RIGOH	Technical B	Bulletin	No.	F/L Series-001
SUBJECT: Introduction of the New	Tools for ROM/RAM [	Data Change		<b>DATE:</b> Apr. 30, 1995
PREPARED BY: Y. Okunishi CHECKED BY: M. Iwasa FROM: 2nd		d T.S. Section		
CLASSIFICATION:	_		MODE	L:
Action Required Revision of service manual		FX	(6, FX4, LSO	
Troubleshooting	Information only			
Retrofit Information	Other

**SUBJECT:** Introduction of the New Tools for ROM/RAM Data Change

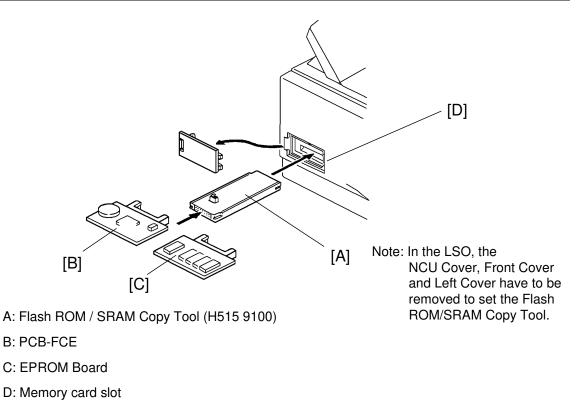
The Flash ROM / SRAM Copy Tool [A] is inserted into the memory card slot [D], then the FCE [B] or EPROM Board [C] with new software is connected to the opposite side of the tool.

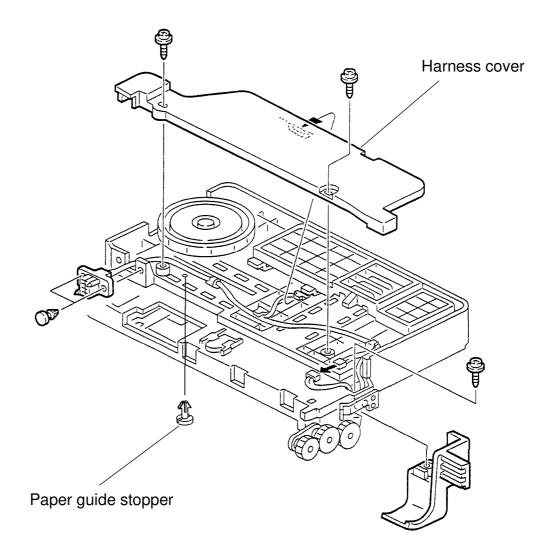
To increase the safety margin for dropping, a holder has been added as shown below from July production at the factory.

Adjustment procedure

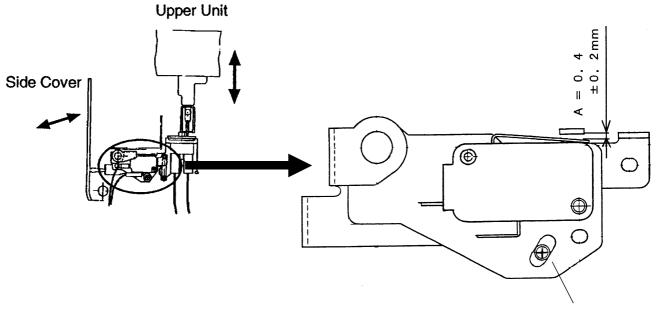
- 1. Install the new interlock switch assembly.
- 2. Loosen the adjustment screw and adjust the gap A to 0.4  $\pm\,$  0.2mm using a thickness gauge.
- 3.Open the upper unit (keep the side cover closed) and make sure that the 5V switch goes to OFF.
- 4.Close the upper unit and open the side cover. Then make sure that the 5V switch goes to OFF.
- 5. Assemble the machine.

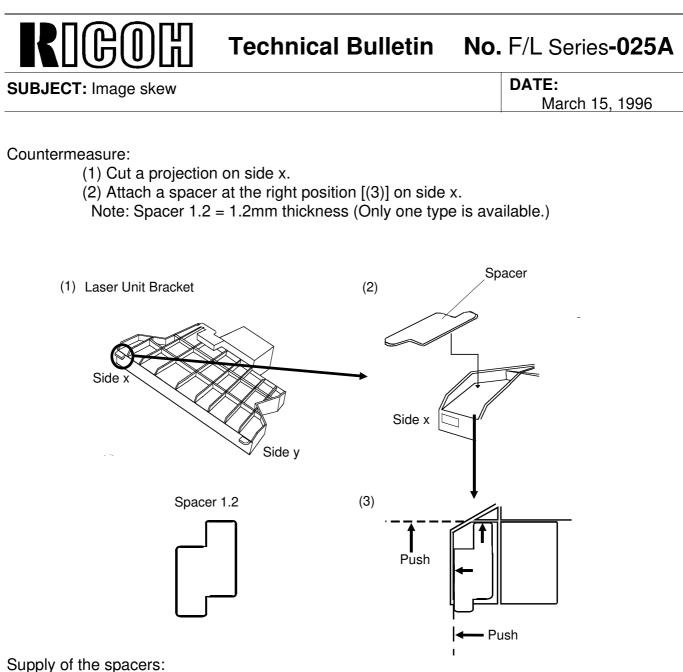
The skew happens for horizontal lines but not for vertical lines. a<b

- Cause: The heights of the fixing holes for the laser unit are not even. x < y
  - So, the laser unit is not set parallel with the drum.

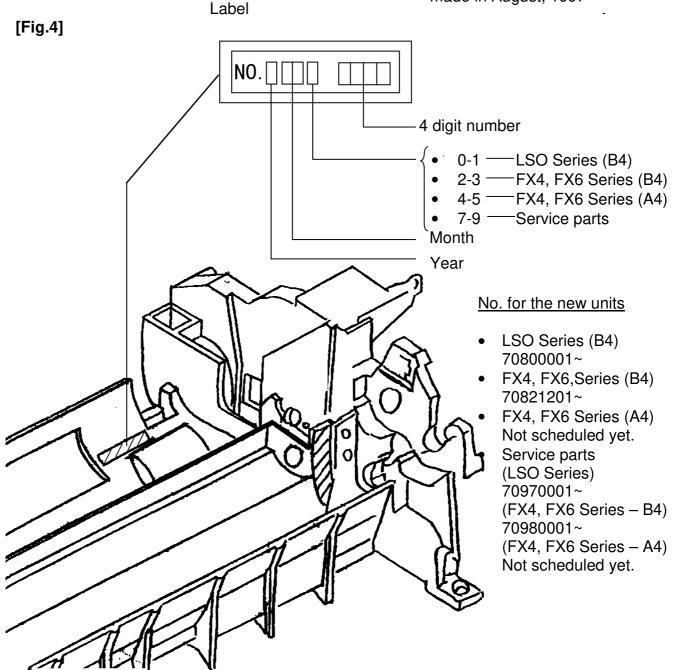
The development units are modified to improve the flow of toner in the development unit. See Fig.1 on the attached page. This modification reduces the following problems.

- < Development Unit (B4) for FX4, FX6, FX6MK2, for Taiwan and Japan> H515 **9070** → **9071** : August 1997 production.
- <Development Unit (A4) for FX4, FX6, FX6MK2, FX6CD for other countries> H515 **9570**  $\rightarrow$  ? : The modification schedule is not fixed yet.
- Interchangeability is O/O.
- Note: You can distinguish the modified Development Unit by the lot no. printed on the label. See Fig.4 on page 3.
